**HMV Empire Coventry Observations - Thursday, 20th November, 2025**

# Introduction

# Main Room Floorplan - Not to Scale

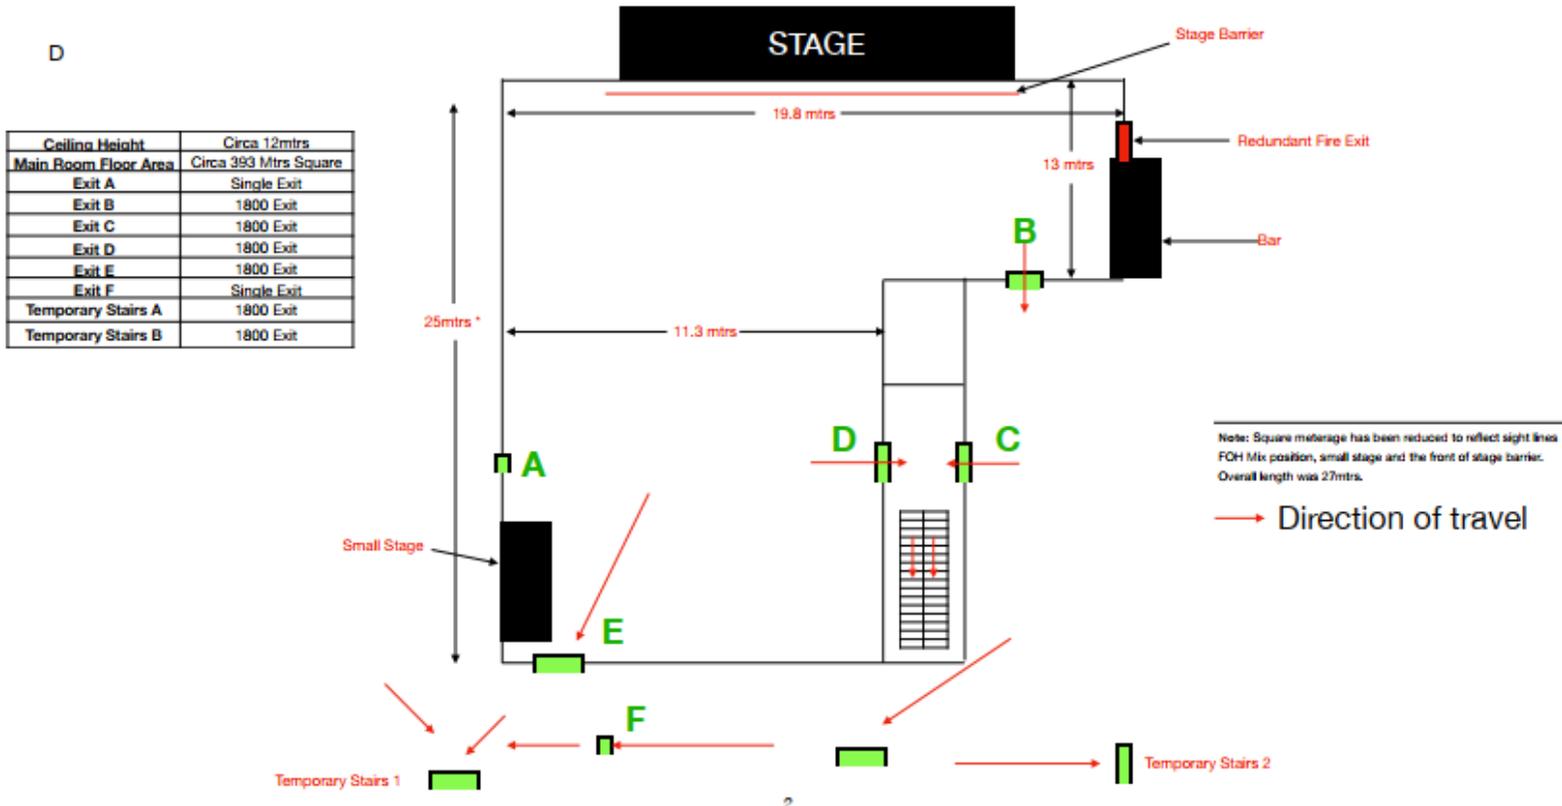
- **Exit A** - It was unclear to me if this exit was in use even though the sign was illuminated
- **Exit B** - Led through to the main bar towards Final Exits.

- **Exit C** - Fed from the Main bar area to the lobby at the top of the escalators. This lobby would have to cope with merging flows via **Exit D** and a reduced flow rate of the escalators which could only cope with a flow of single persons on each tread. The effective width of each escalator was measured as: **718mm** The combined effective width, of both escalators was **1436mm**.

- **Exit D** - Fed from the main room and would be reduced with merging flows from **Exit C** restricting flow rate. The combined effect of the 2 x 1800mm doors, feeding into escalators with an overall effective width of **1436mm** could create a bottleneck and further restriction of flow rate.

- **Exit E** - an **1800mm** double door which was restricted by the proximity of a raised smaller stage thereby reducing the effective width of these doors.

- **Exit F** - a single door exit located in the area adjacent to the balcony. This was obstructed by loose chairs and could impact flow rate in the event of an emergency.

- **Temporary Stair 1** - was served by a circa **1800mm** double door, with push bar. The internal width of the stairs was measured as **1612mm**. This route would have to contend with merging flows from **Exit E**, **Exit F** relevant persons descending from the toilets.

- **Temporary Stair 2** - was served by a circa **1800mm** double door, with push bar. The temporary staircase protruded into the lobby area reducing the available space to **1360mm** which would create a bottleneck and restrict flow through this area. Furthermore, the stairs created a 90 degree right turn which would further restrict flow.

- The largest exit was **Temporary Staircase 1**, which should be discounted from the overall exit capacity.
- Of note, other than **Exit A**, I did not observe any security staff positioned by exits (with exception of **Exit A**) or Final Exits of the temporary staircases, throughout the observational site visit.
